Project: PRA-ROCR 10(5)
The purpose of this Amendment is to:

Amendment No. 0002
Project PRA-ROCR 10(5)
Rock Creek Park
Solicitation: DTFH71-16-R-00001

Project Name: Beach Drive from Rock Creek Parkway to Maryland State Line

AMENDMENT NO. 2 ◇1	PMIS NO.	NPS NO.	STATE	PROJECT	SHEET NO.
	044965	821 / 100425	DC	PRA-ROCR 10(5)	D20

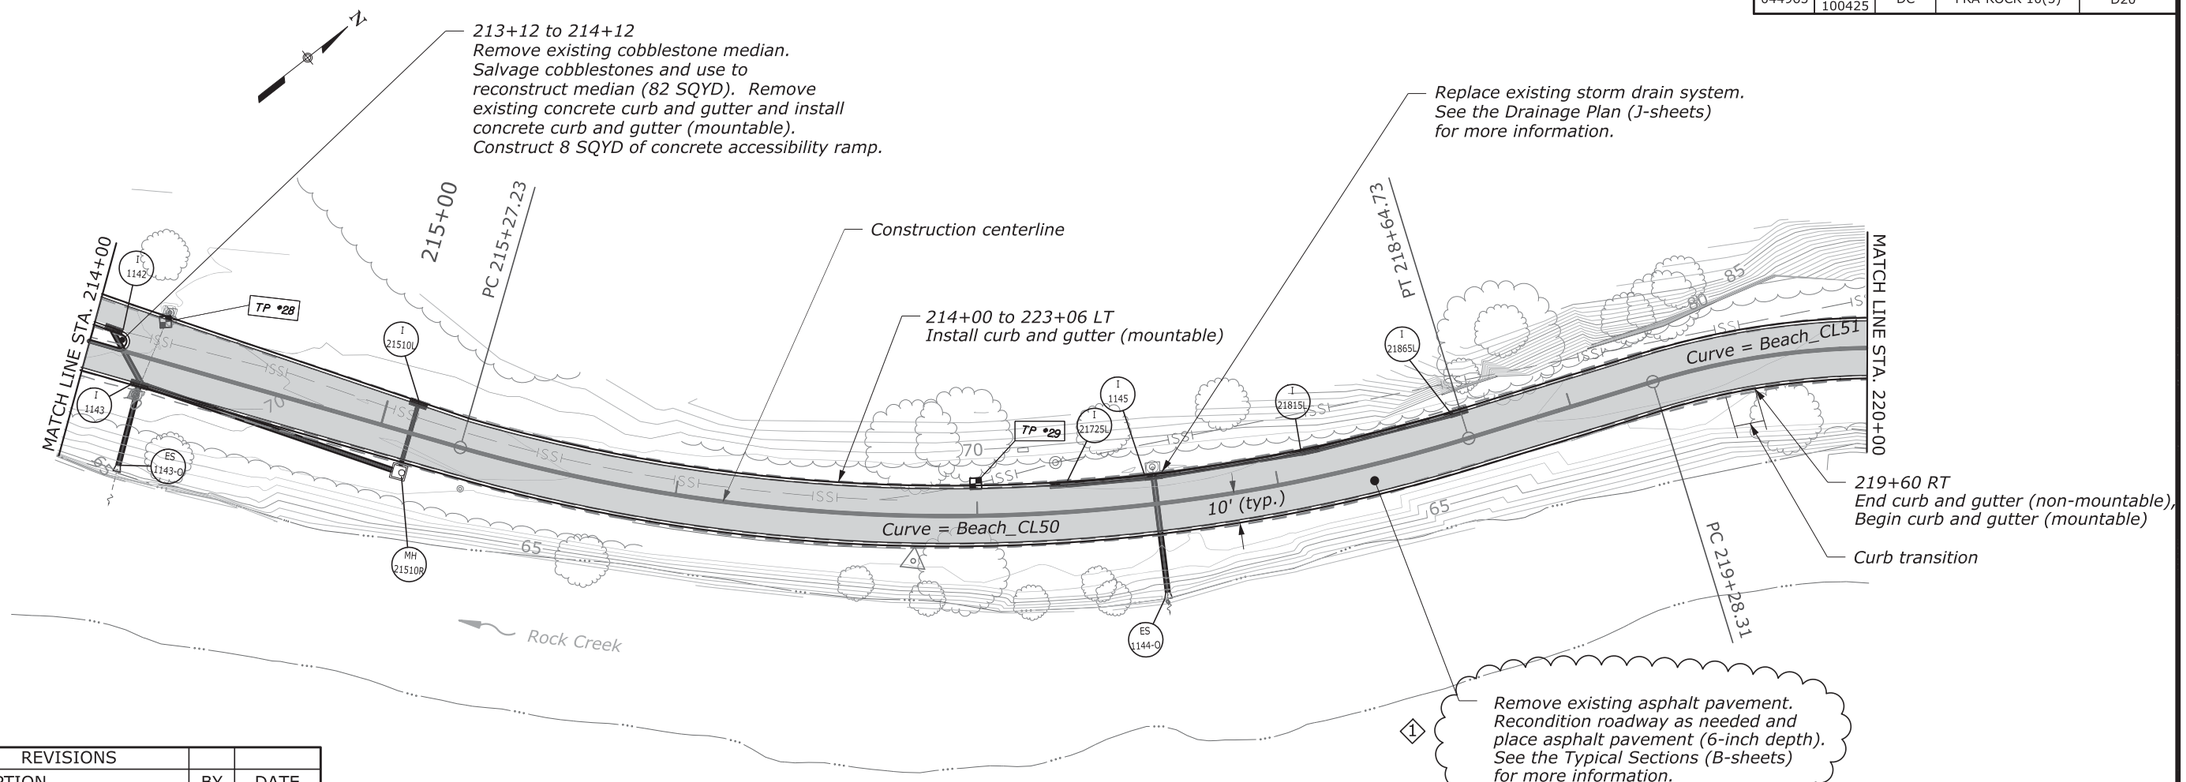
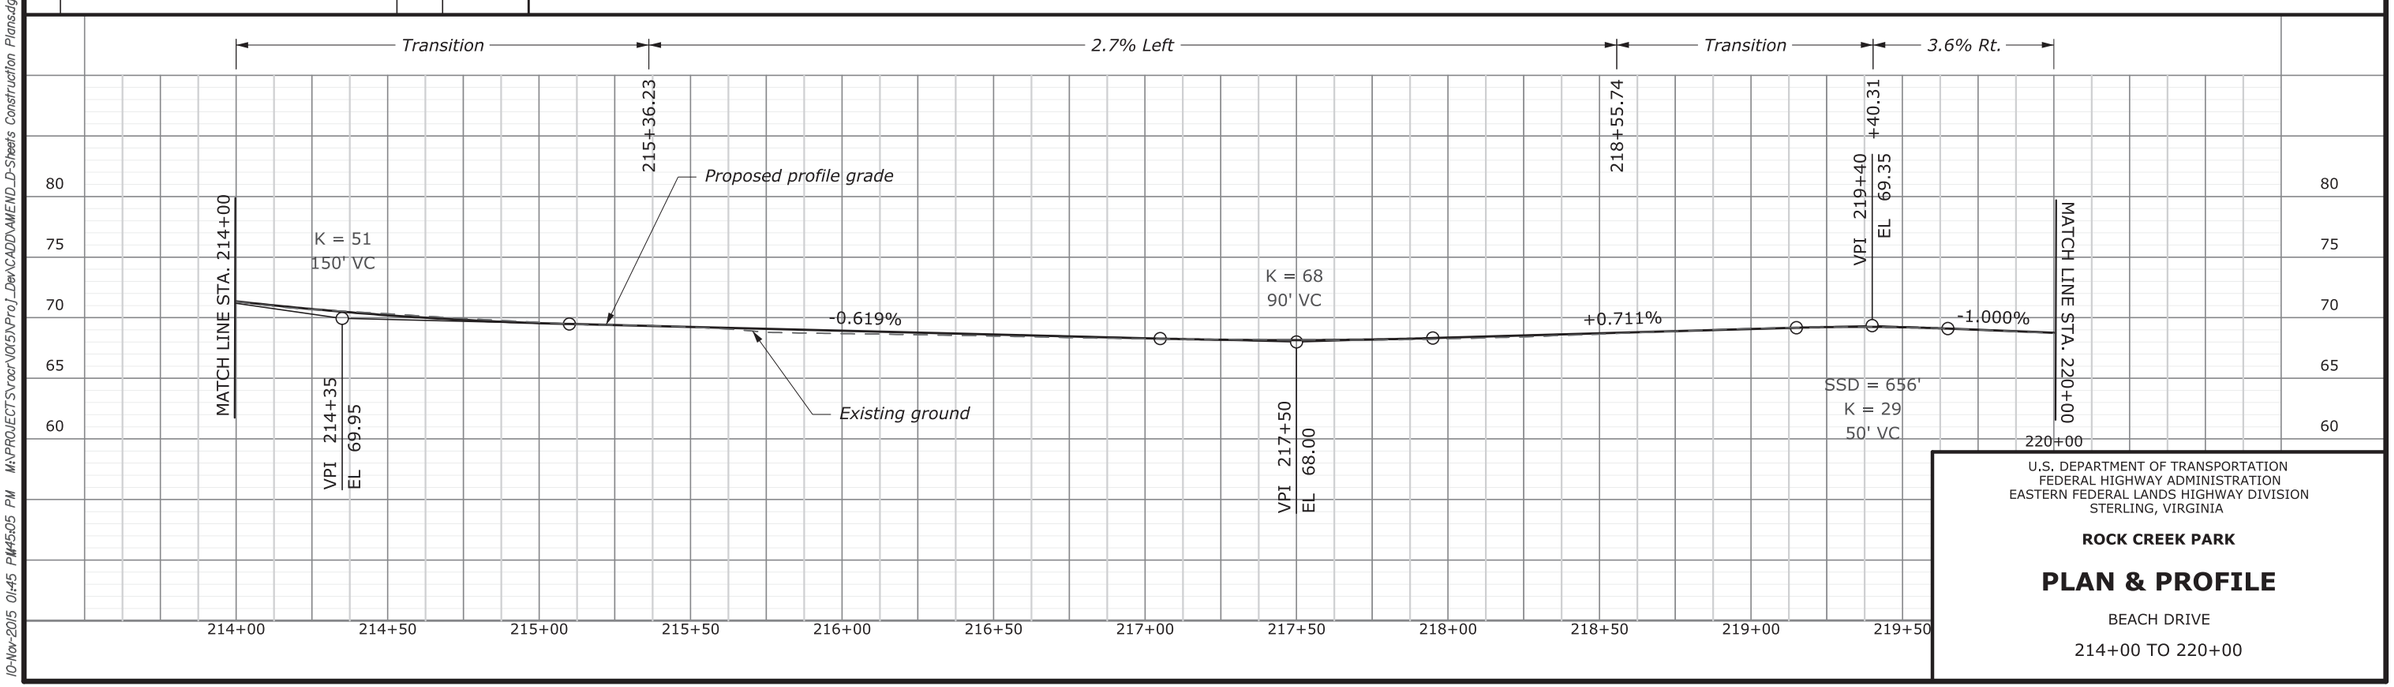
REVISIONS			
NO.	DESCRIPTION	BY	DATE
◇1	Revised the callout to remove the milling requirement.	CC	11/10/15

AMENDMENT NO. 2 ◇1	PMIS NO.	NPS NO.	STATE	PROJECT	SHEET NO.
	044965	821 / 100425	DC	PRA-ROCR 10(5)	D21

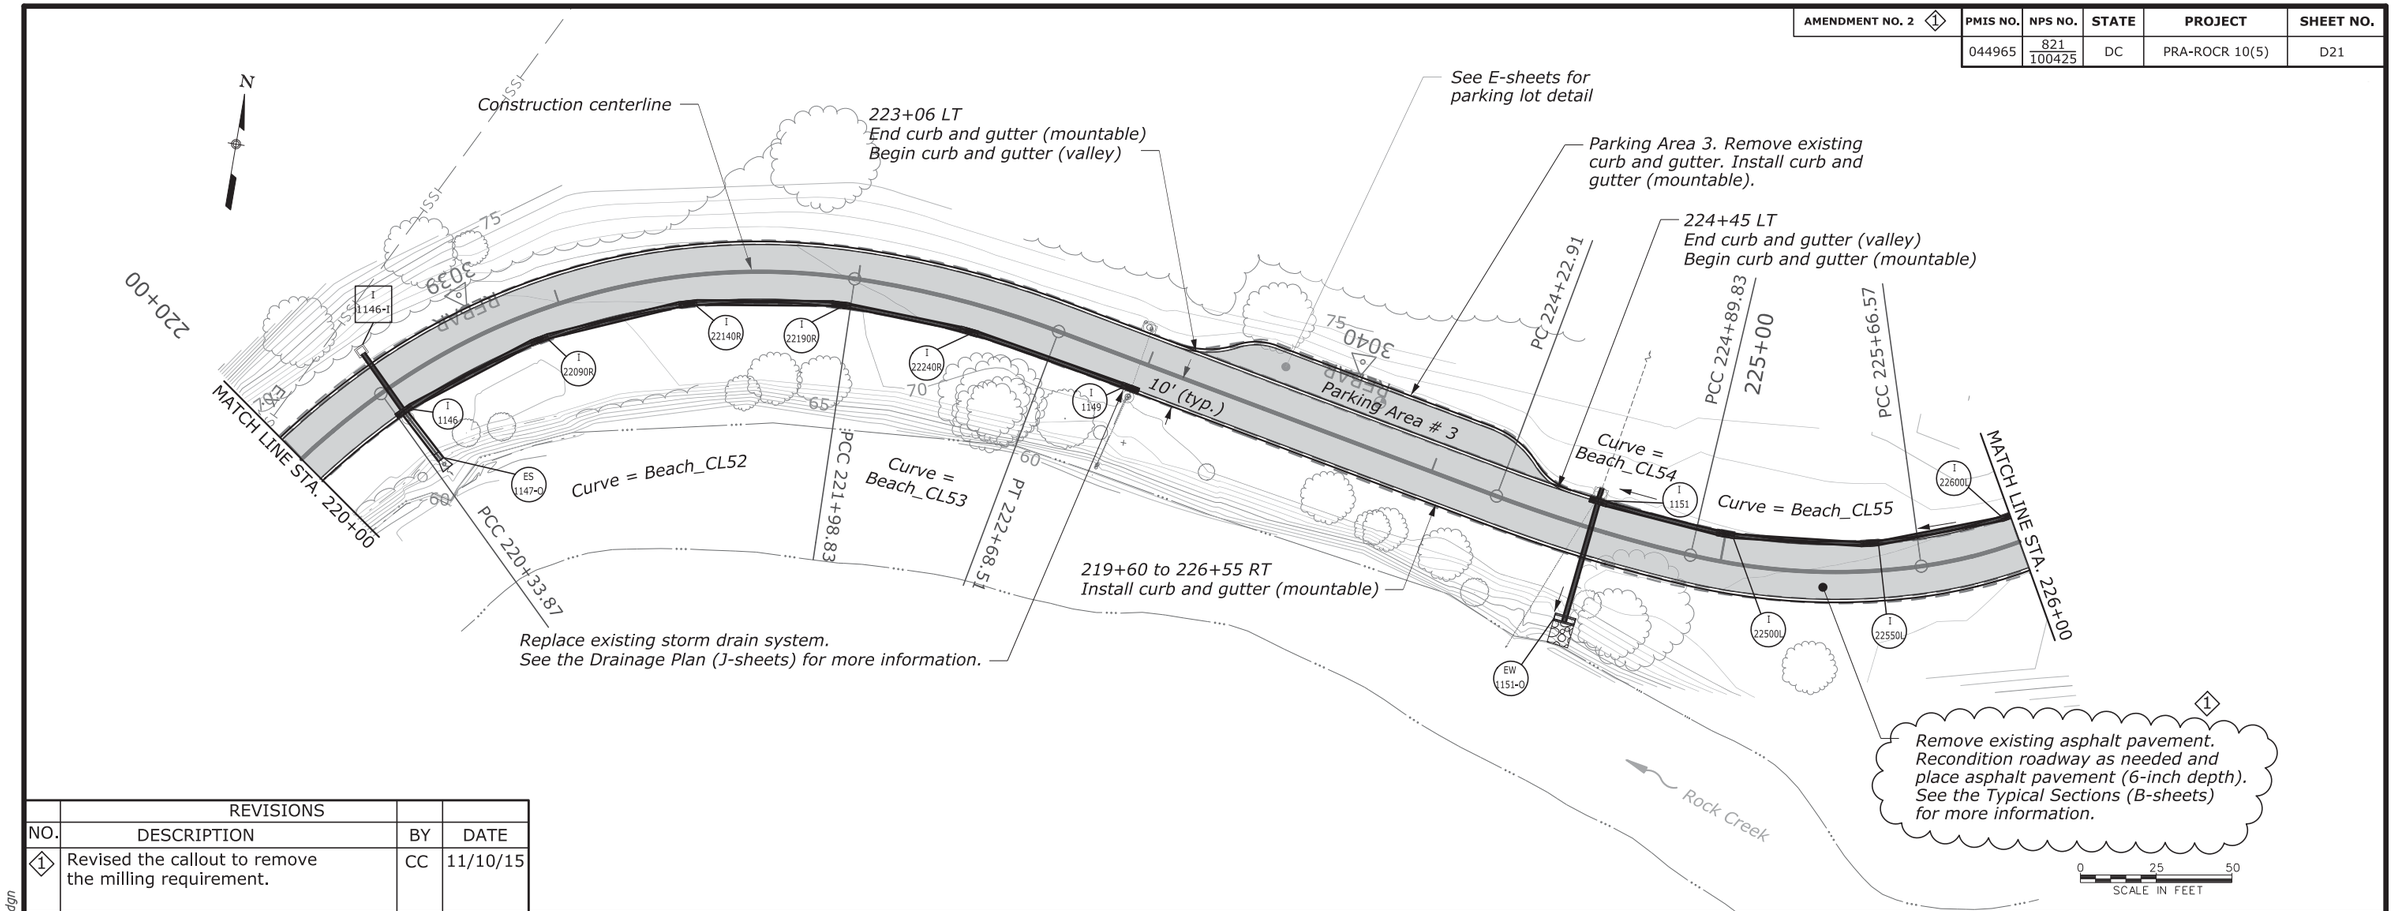
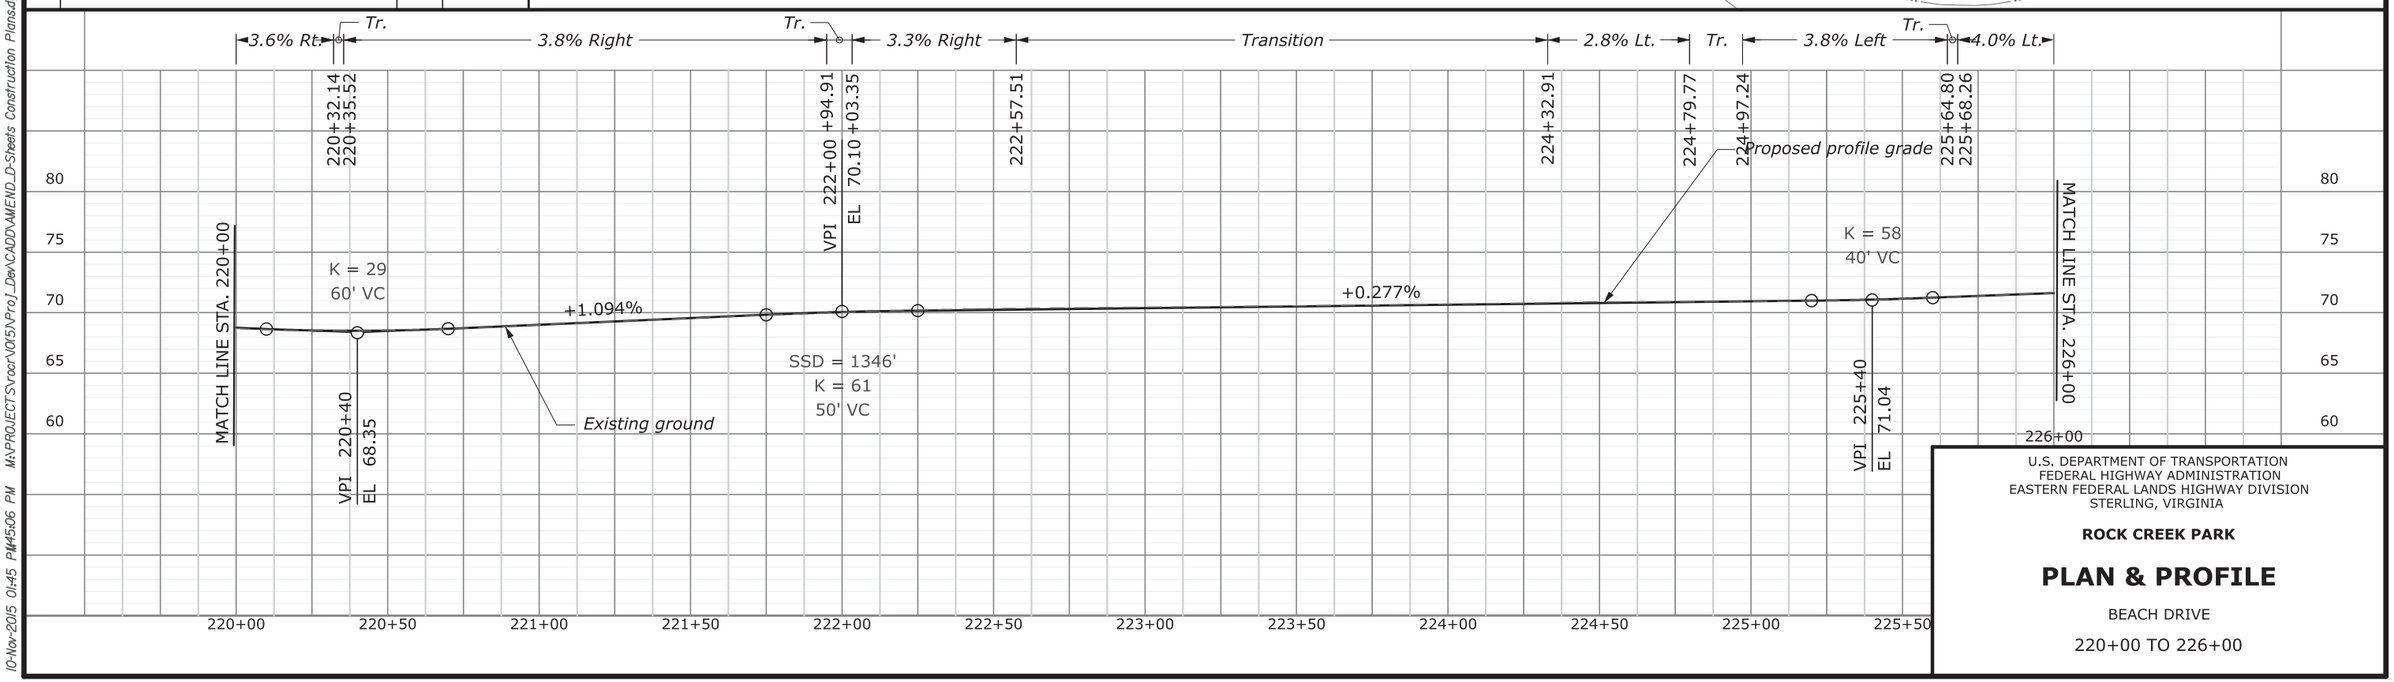
REVISIONS			
NO.	DESCRIPTION	BY	DATE
◇1	Revised the callout to remove the milling requirement.	CC	11/10/15

AMENDMENT NO. 2 ◇1	PMIS NO.	NPS NO.	STATE	PROJECT	SHEET NO.
	044965	821 / 100425	DC	PRA-ROCR 10(5)	D22

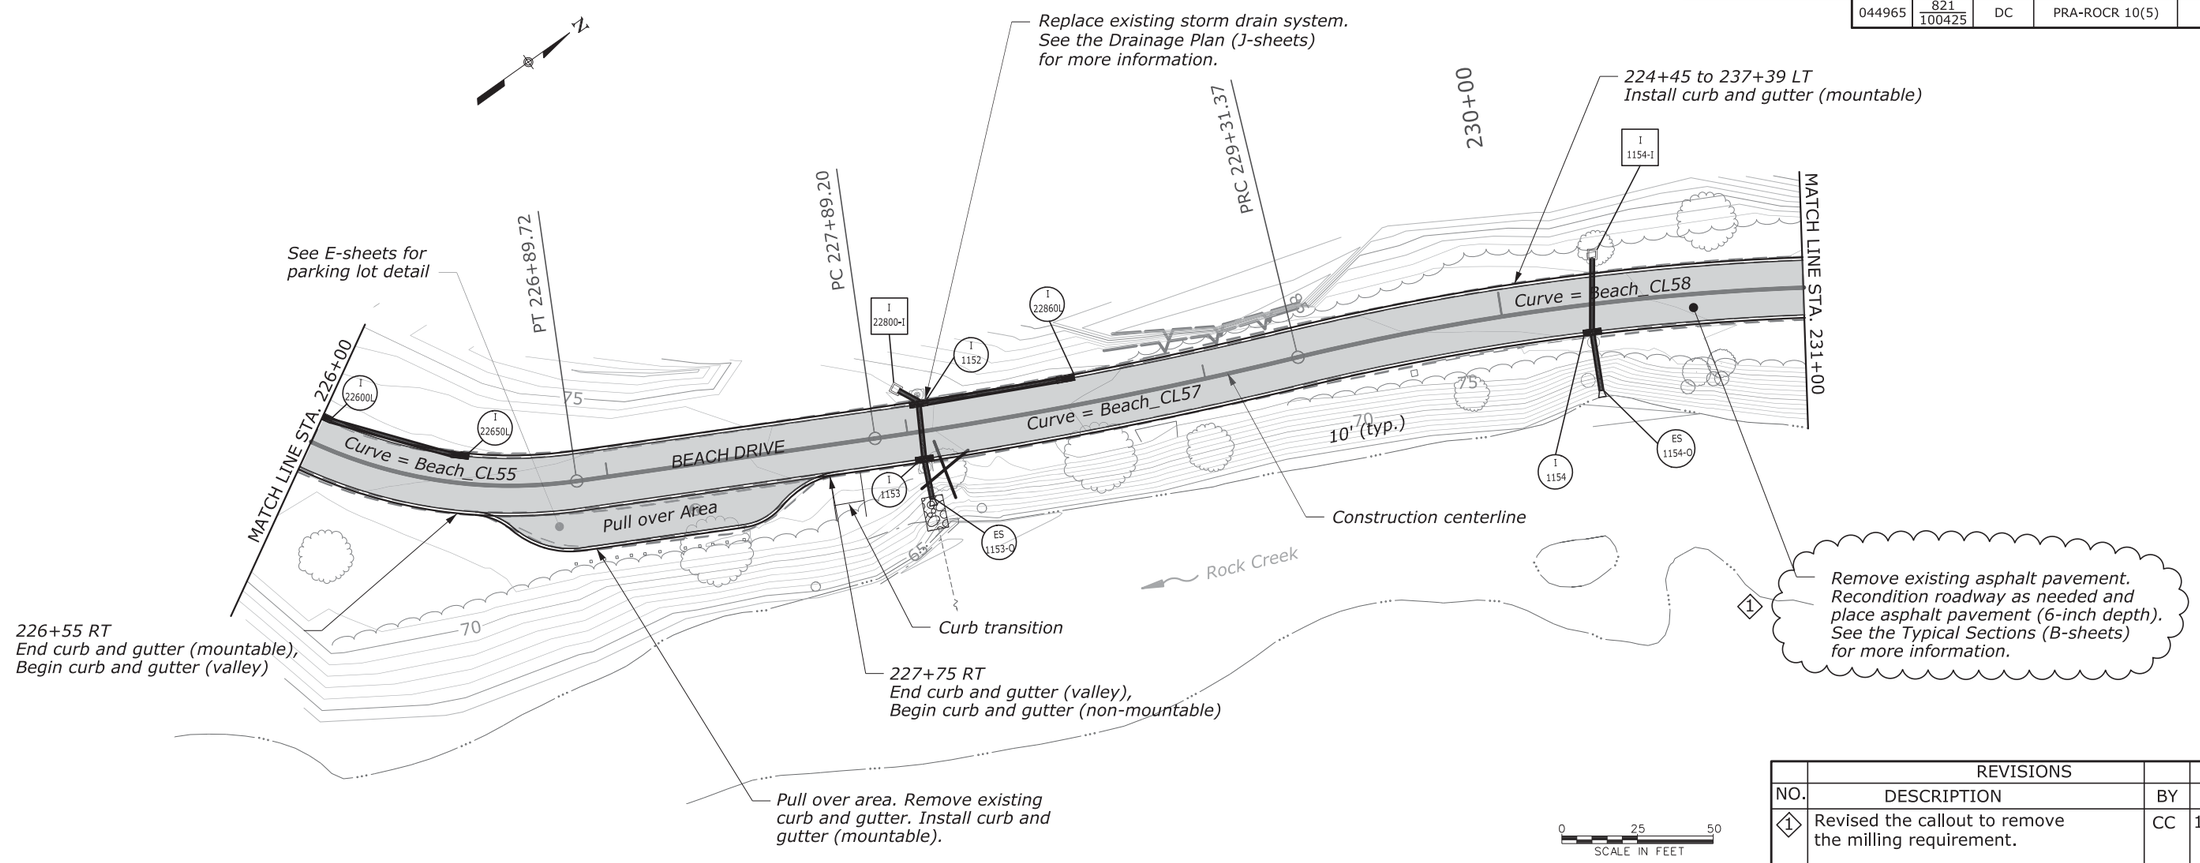
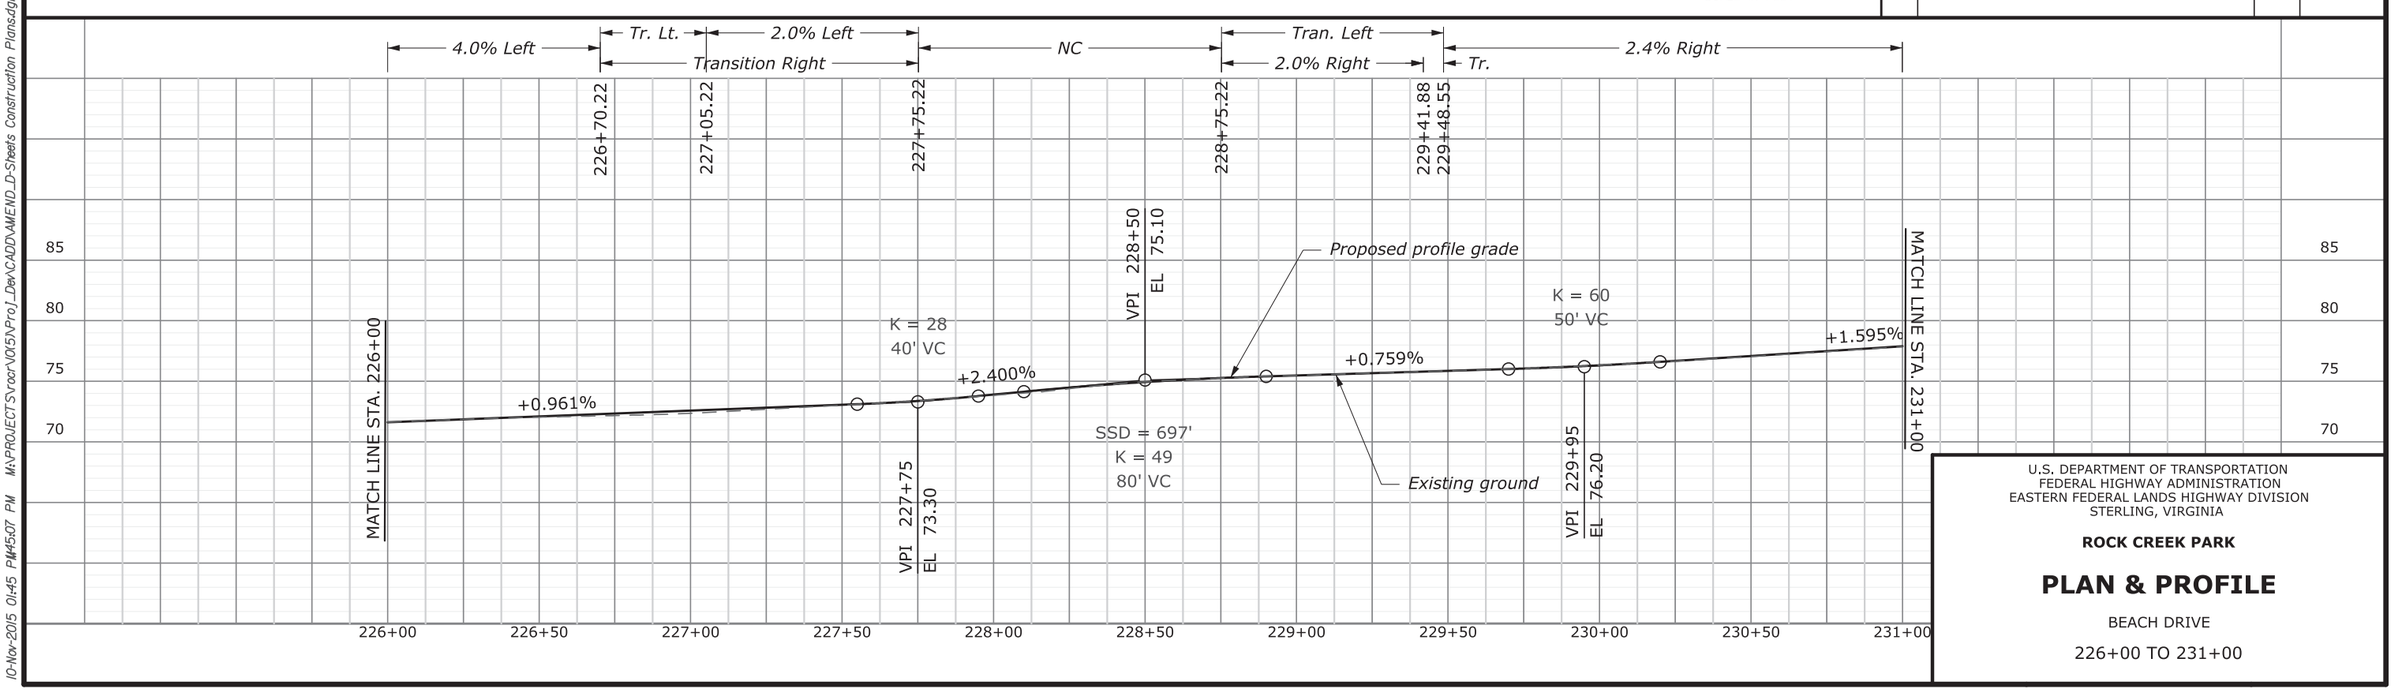
REVISIONS			
NO.	DESCRIPTION	BY	DATE
◇1	Revised the callout to remove the milling requirement.	CC	11/10/15
